MODEL DEPENDENT PARTS FOR LT/ST 6083 PCB

LT/ST SWITCHING AMPLIFIER

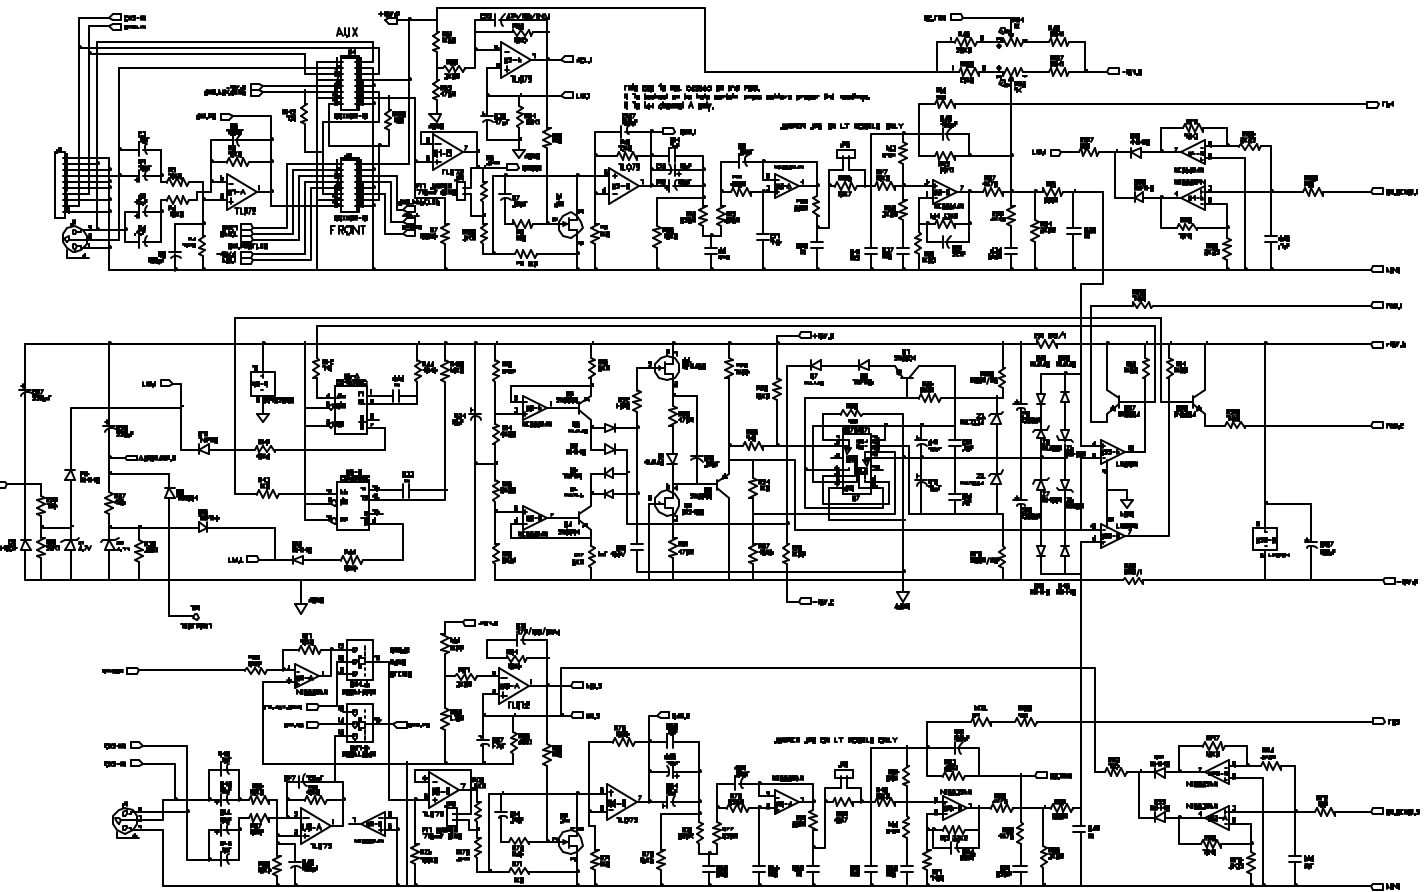
LT-604 added C47 is needed for R48 for the purpose of reducing THD in channel A.
LT-605 removed R48A from channel B circuit for the purpose of R48A reducing THD.
LT-607 added pinic security to pin 17 of IC1, IC2 and IC3.
